26 June 2020
Document Id. 02891U-02L4
Serial No. 19363

SUBJECT: SUPPLEMENTAL EVALUATION
PROPOSED SITE RETAINING WALLS AND
LANDSCAPING IMPROVEMENTS
DUTTA PROPERTY
250 BONITA ROAD
SAN MATEO COUNTY, CALIFORNIA

SUBJECT: SUPPLEMENTAL RECOMMENDATIONS AND PLAN REVIEW
PROPOSED SITE RETAINING WALLS AND
LANDSCAPING IMPROVEMENTS
DUTTA PROPERTY
250 BONITA ROAD
SAN MATEO COUNTY, CALIFORNIA

SUBJECT: PLAN REVIEW
PROPOSED SITE RETAINING WALLS AND
LANDSCAPING IMPROVEMENTS
DUTTA PROPERTY
250 BONITA ROAD
SAN MATEO COUNTY, CALIFORNIA

LANDSLIDE INTERPRETATION MAP			
		DUTTA PROPERTY 250 Bonita Road San Mateo County, California	
DRAFTED/REVIEWED KK/CH	SCALE As Shown	DOCUMENT ID. 02891U-0214	DATE June 2020
			Figure 1

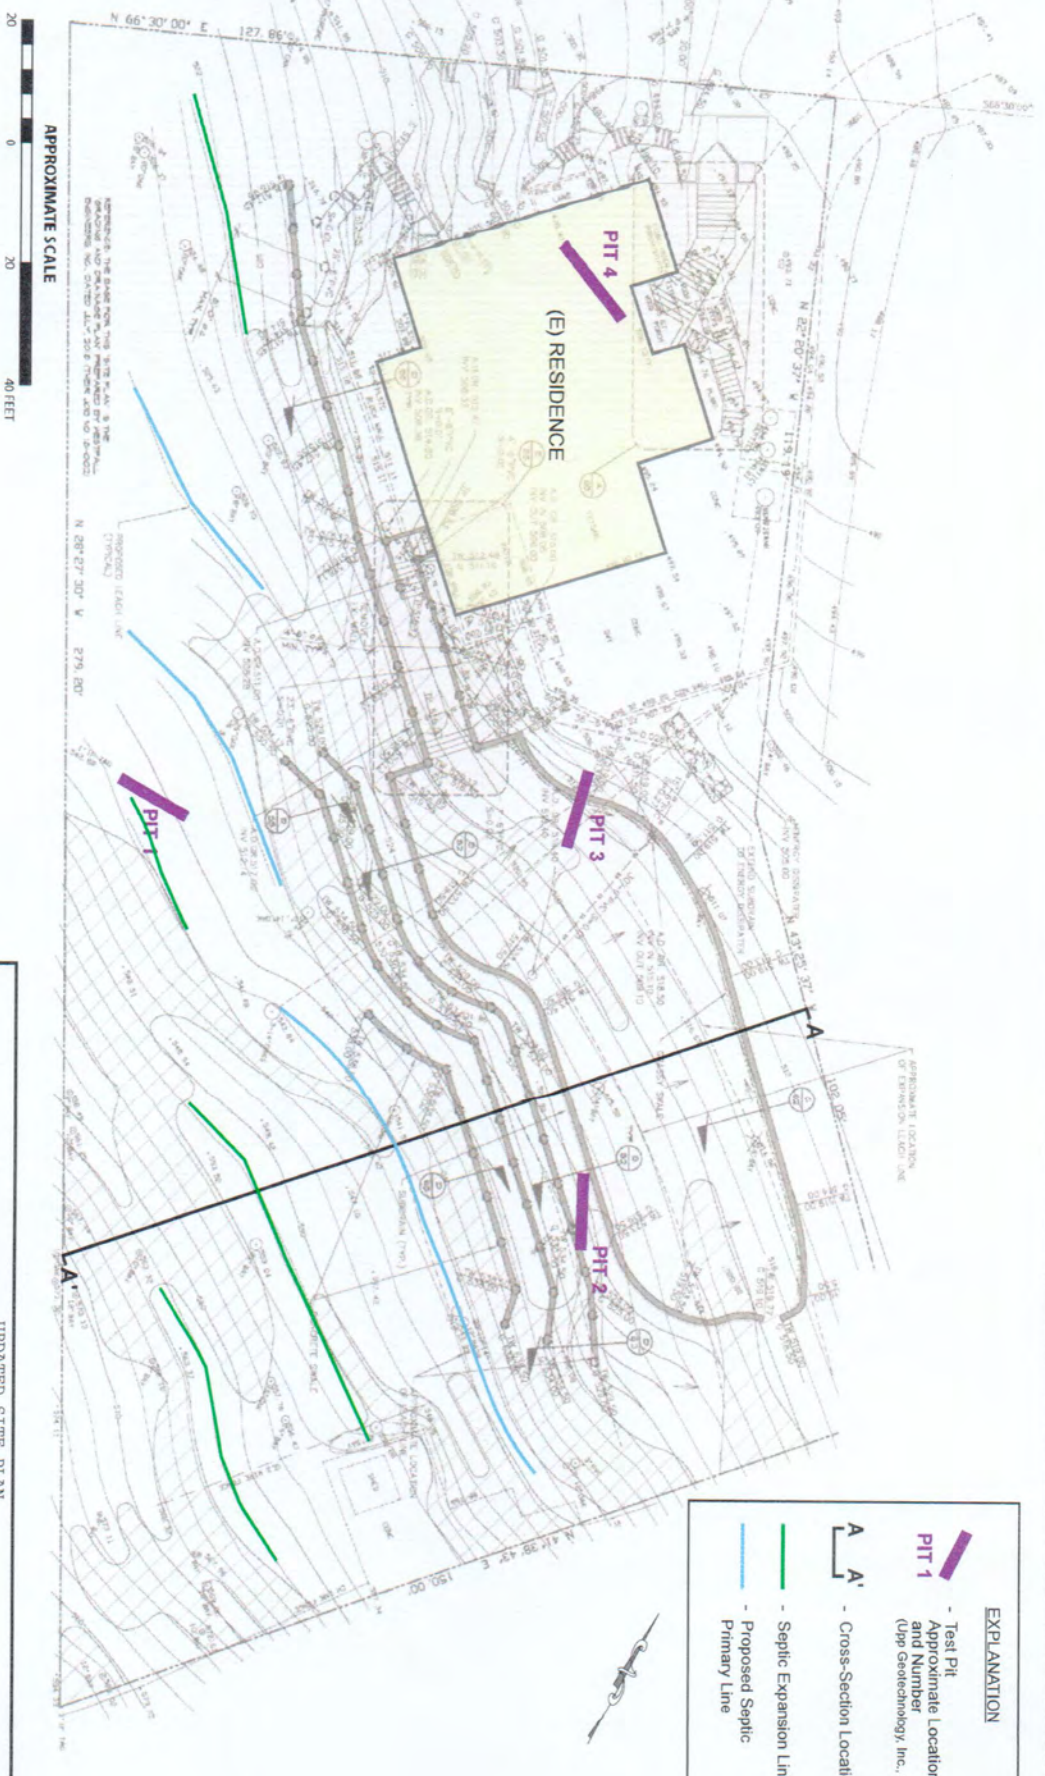
We understand that the County's Geologic and Geotechnical Peer Review consultant has identified a possible landslide deposit in the area of the proposed improvements from the review of Lidar imagery. Based on our review of stereo-paired aerial photographs and Lidar imagery, we concur that the area may be within a landslide deposit (see Figure 1, Landslide Interpretation Map).

UPDATED CROSS SECTION A-A'

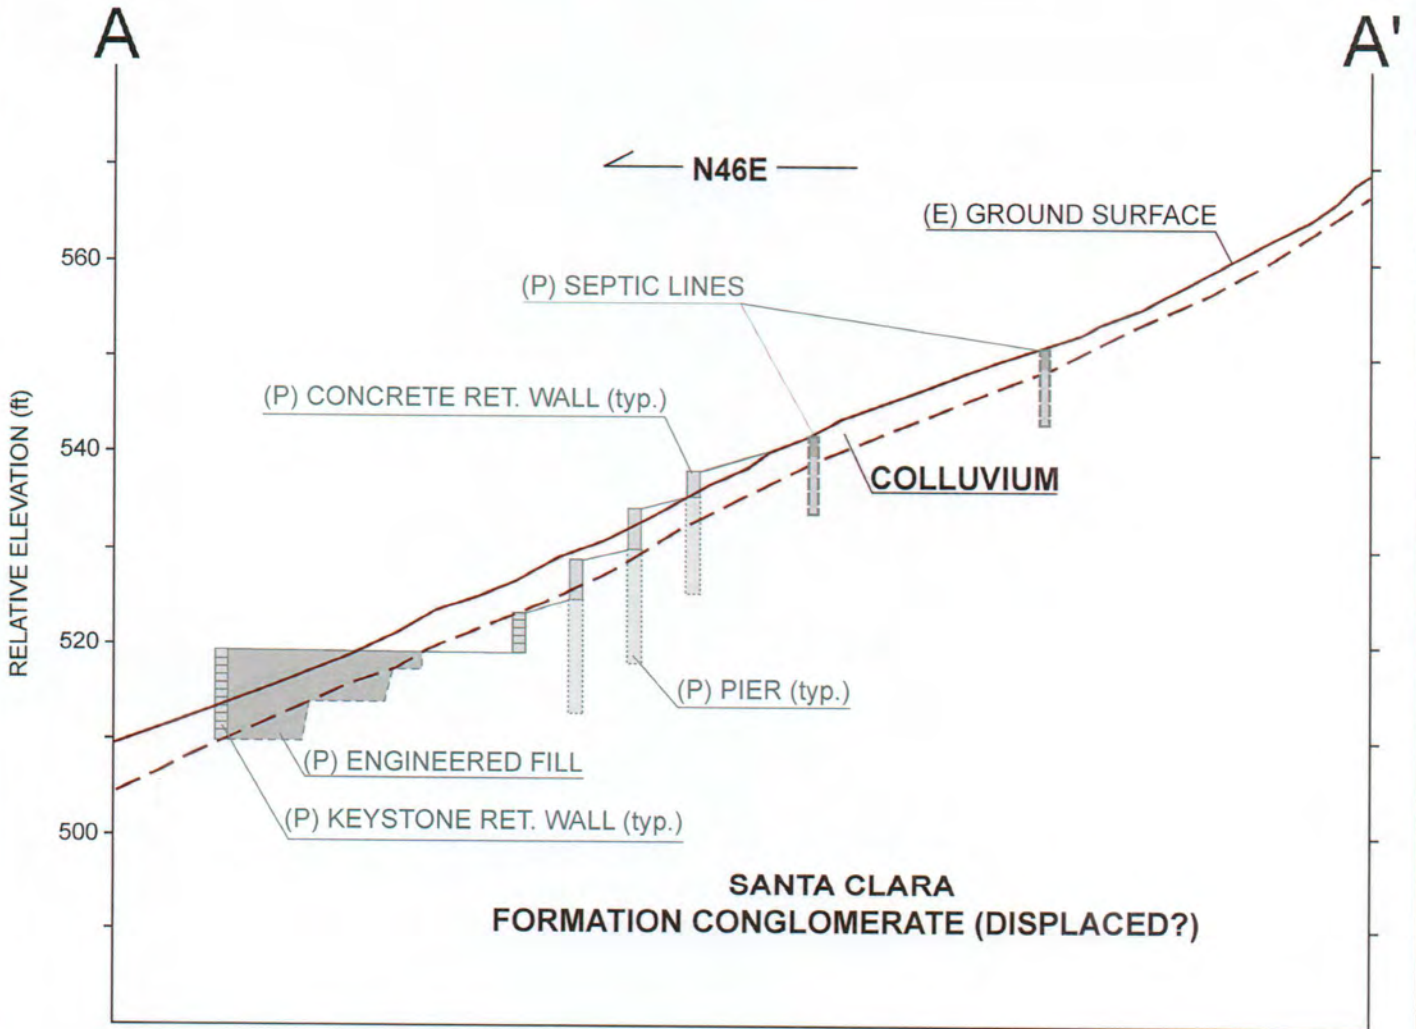
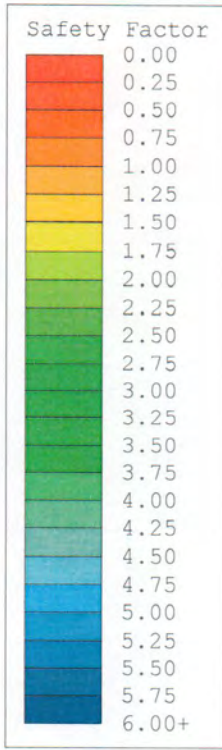
We performed the slope stability analyses utilizing the existing and proposed surface profiles depicted on Figure 3, Updated Cross-Section A-A'. We generated this profile using topographic information and proposed retaining wall configurations presented on the project Structural Plan Sheet S1 by Schneider Engineering (Revision 1 dated 10 February 2020). Subsurface information was applied based upon our experience and existing available test pit and construction observations data.

Based upon the thin layer of soil and colluvium mantling the Santa Clara formation materials on-site, we judge that proposed septic field lines will discharge effluent into the Santa Clara formation conglomerate (see Figure 3). The percolation test rating "A" with a rate of 7.35 inches per hour will result in good downward migration and percolation through the Santa Clara formation conglomerate.

SLOPE STABILITY ANALYSIS NO. 1

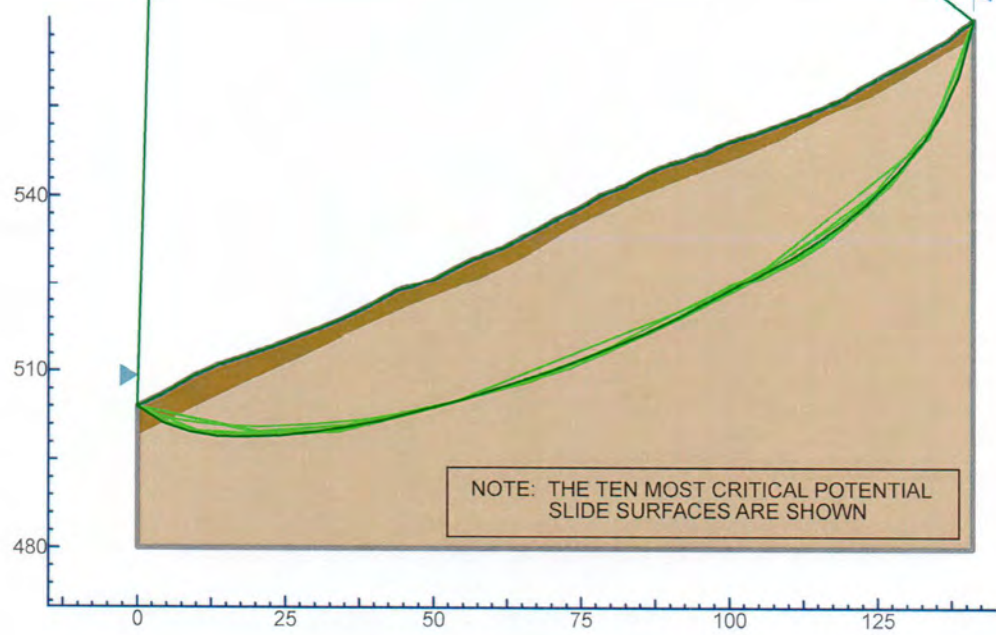
Slope Stability Analysis No. 1 and 2 evaluated the potential for global, deep-seated landsliding to occur under static conditions for the current and proposed site conditions, respectively. The lowest factors of safety for each analysis is presented in the following table and graphical illustrations of potential failure surfaces are shown on Figures 4 and 5, Slope Stability Analysis No. 1 and 2).

Our comparative evaluation revealed the proposed project has no negative influence on the overall stability of the site. Rather, the proposed grading configuration, removing material from on the slope and placing it lower on the slope retained by walls, will yield a slightly increased level of slope stability. Consequently we judge from geologic and geotechnical perspectives, that the proposed project may proceed as planned.
